# UNITED STATES PATENT AND TRADEMARK OFFICE

APPLICATION NO.	FILING DATE	FIRST NAMED INVENTOR	ATTORNEY DOCKET NO.	CONFIRMATION NO.
10/751,386	01/05/2004	Eric Engler	90564.1	2664
23573	7590	09/16/2004	EXAMINER	
HOLLAND & KNIGHT, LLP ONE EAST BROWARD BLVD. SUITE 1300 FT LAUDERDALE, FL 33301			LEE, JONG SUK	
			ART UNIT	PAPER NUMBER
			3673

<b>Office Action Summary</b>	<b>Application No.</b> 10/751,386	<b>Applicant(s)</b> ENGLER, ERIC	
	<b>Examiner</b> Jong-Suk (James) Lee	<b>Art Unit</b> 3673

## **DETAILED ACTION**

Attachment: Fig.1 of Chang (US 3,896,624)

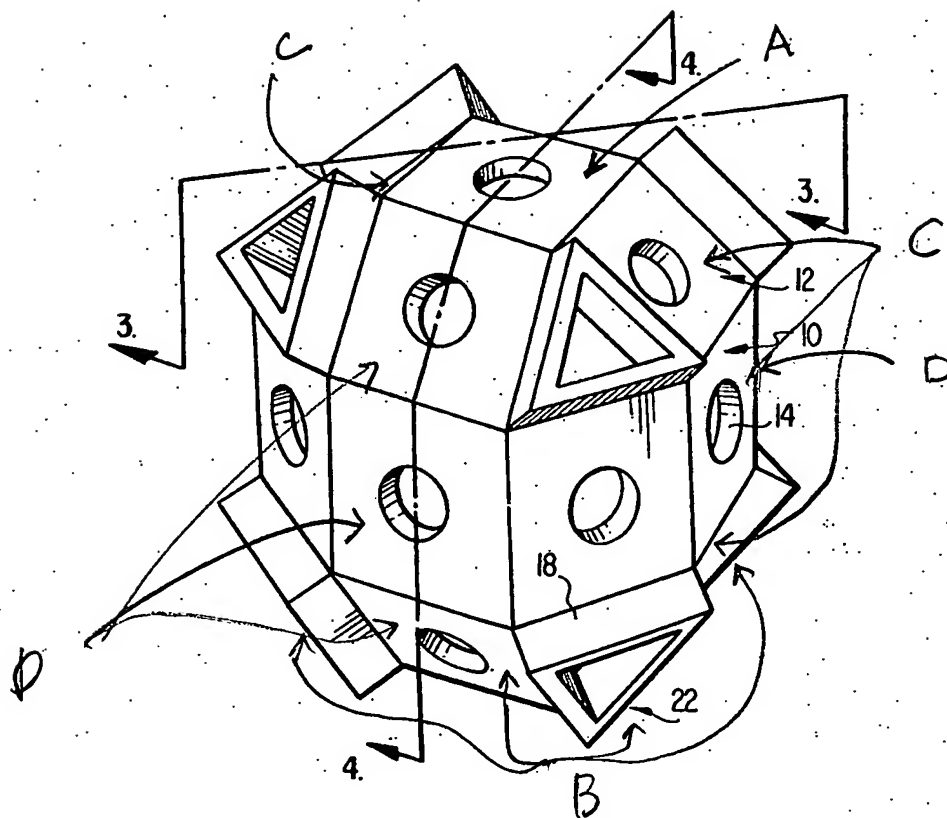
Chang discloses a structure block comprising of: a modular unit having a top wall (A), a bottom wall (B), two side walls (C) and two end walls (D) (see attached figure) which are interconnected to form a hollow interior; each of said side walls (C) having a tapered section formed with a through bore (14) which intersects said hollow interior; each of said end walls (D) extending generally vertically between said bottom wall and said top wall, said end walls each being formed with a through bore which intersects said hollow interior; said top wall being

formed with a through bore which intersects said hollow interior; a number of supports (22) extending from said bottom wall, said supports (22) being adapted to assist the stabilization of said modular unit on the floor of a body of water, wherein said through bore of one end wall aligns with said through bore of said other end wall, the tapered section of each of the side walls extending at an angle about 45 degrees, wherein, said supports are a number of legs or a lip (22) extending from said bottom wall, wherein, said modular unit forming an artificial reef and marine habitat along the floor of a body of water and being positioned within a body of water relative to a beach at the edge of said body of water to form a sea wall (see Figs. 5-7) and further said bottom wall being formed with a through bore which intersects said hollow interior and the structure further having an anchoring device adapted to rest upon the floor of the body of water, said anchoring device being formed with mounting structure which engages said at least one support to connect said modular unit to said anchoring device (see Fig. 8) (see Figs. 1-9; col.3, lines 57-68; col.4, lines 1-68; col.5, lines 1-68).
